## ADDENDUM No. 3

**DATE ISSUED: September 6, 2016**

**RE: HIGHLAND AVENUE DRAINAGE IMPROVEMENTS (BID # HDI 027-090816)**

Drawn PJKK  
Checked: EF  
SHEET NO. 002 OF 101

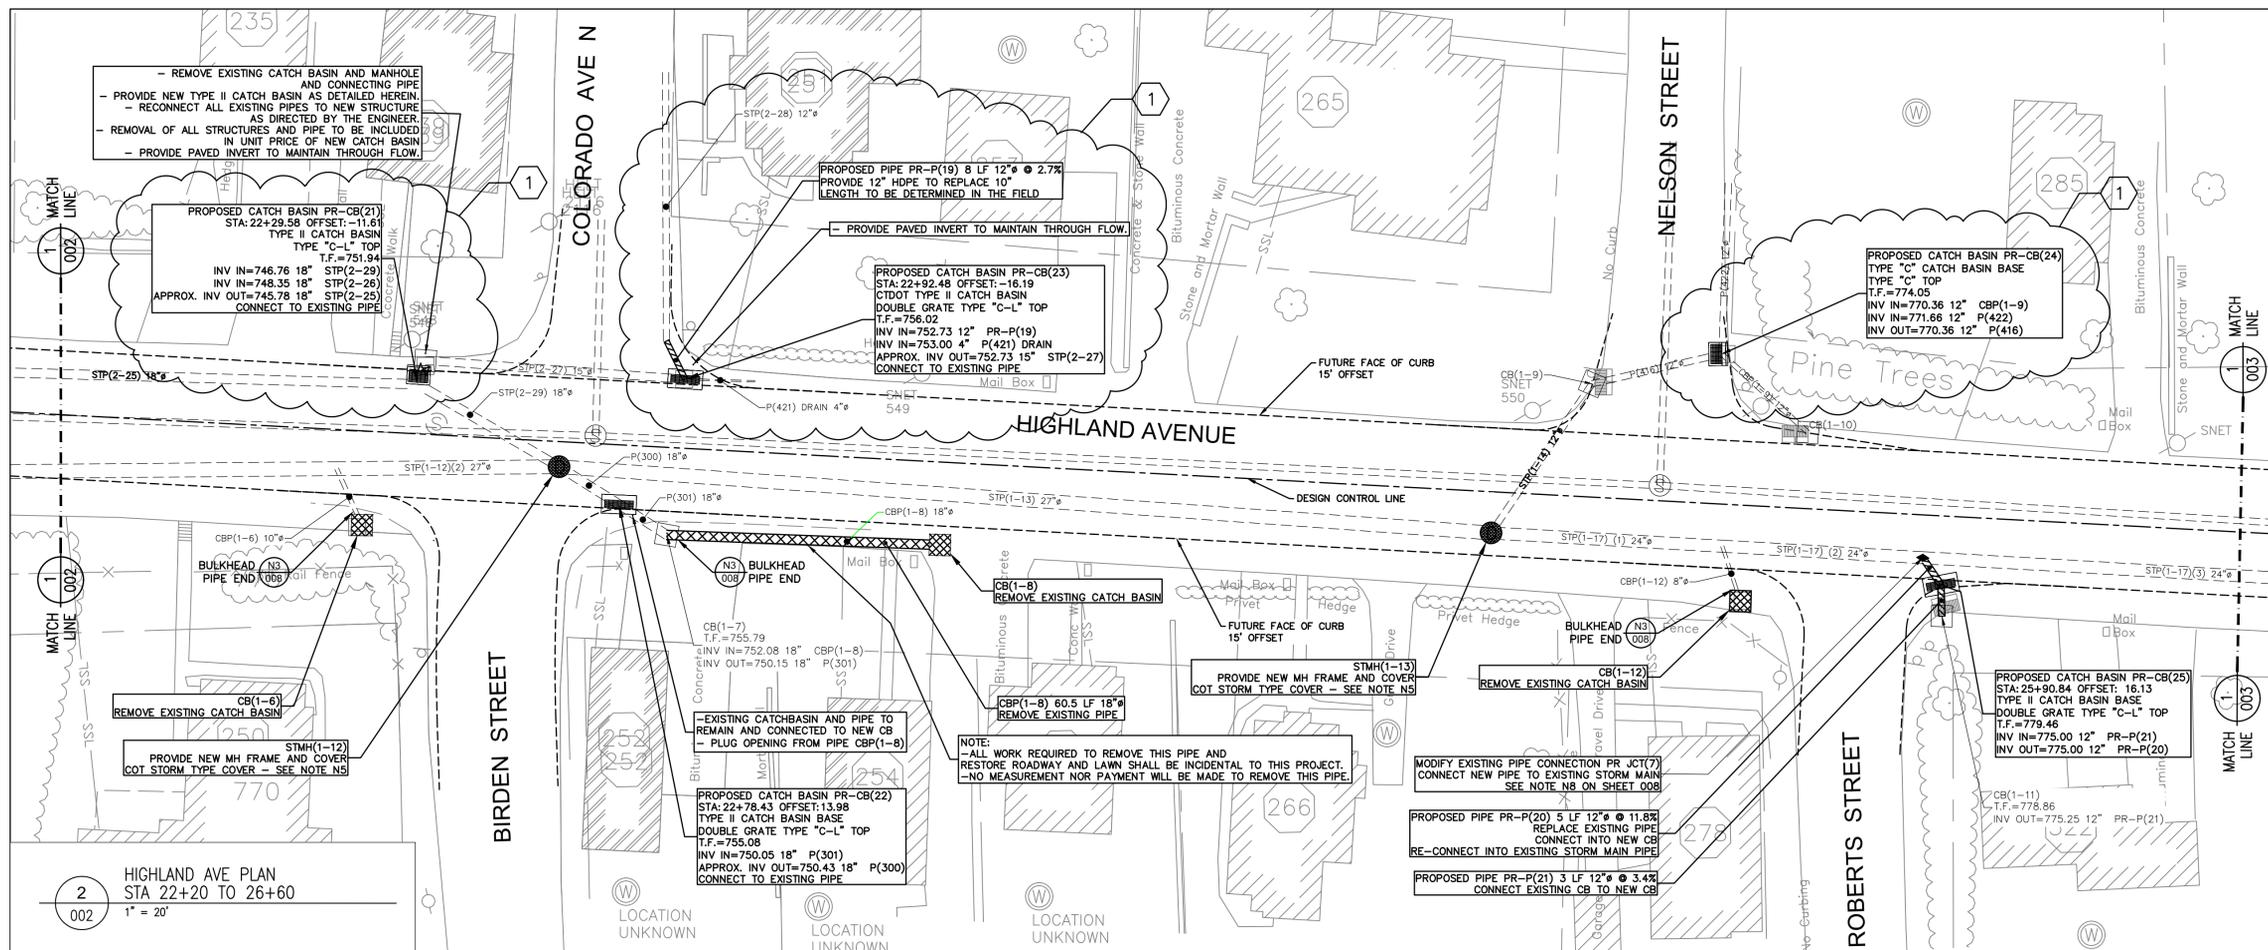
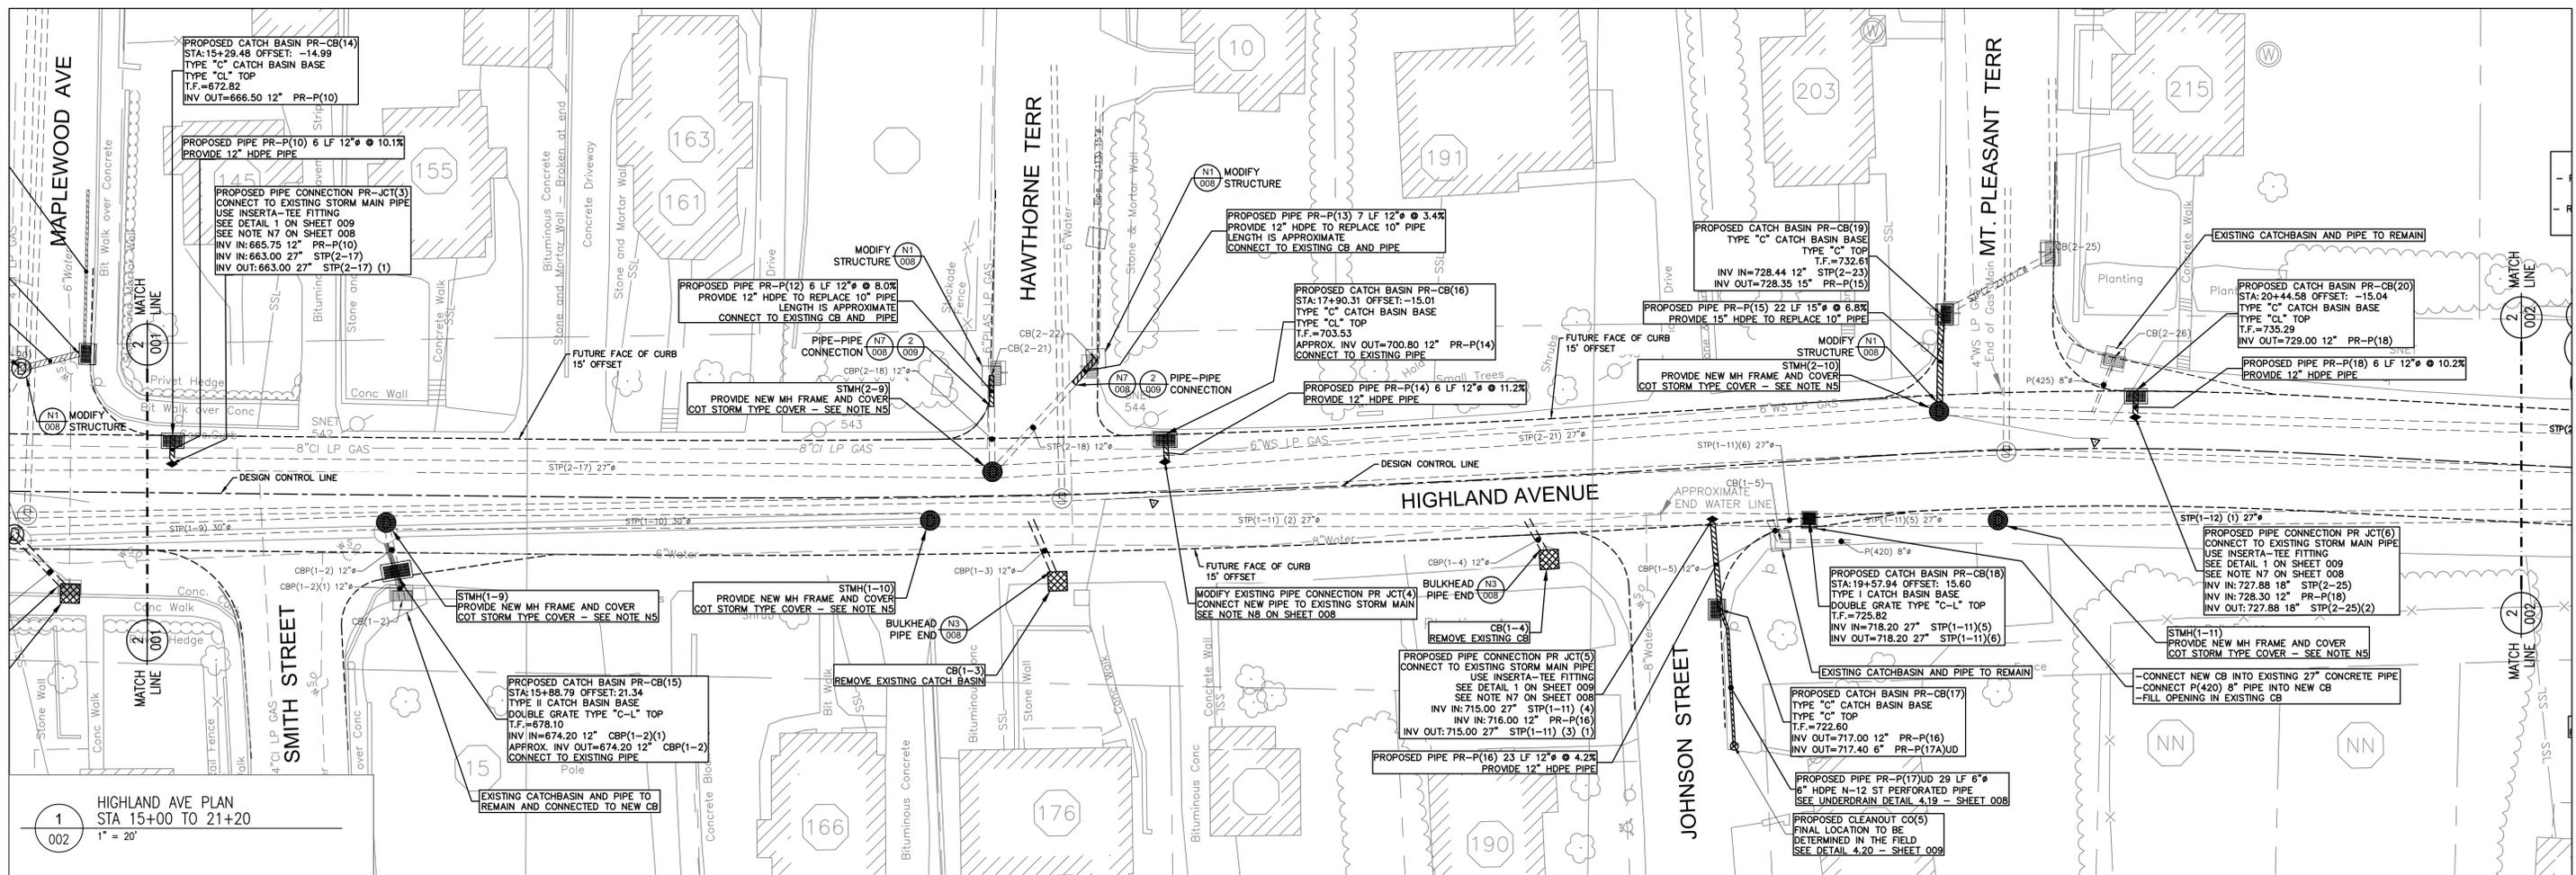
- a. Replace Catch Basin Top **Double Grate Type “C-L” Top** with **Type “C” Top (Single)** and provide a **Conversion Slab** to bridge the double base – off-set opening to align with proposed curb.
- b. This change is considered to have no significant impact on the cost of the structure and therefore this catch basin shall remain to be paid for under bid item 21.
- c. Note revised pipe invert elevations as shown on Plan Sheet 002 (attached) dated 9-06-16.

- a. Note revised pipe invert elevations as shown on Revised Plan Sheet 002 (attached) dated 9-06-16.

- a. Note revised pipe invert elevations as shown on Revised Plan Sheet 002 (attached) dated 9-06-16.
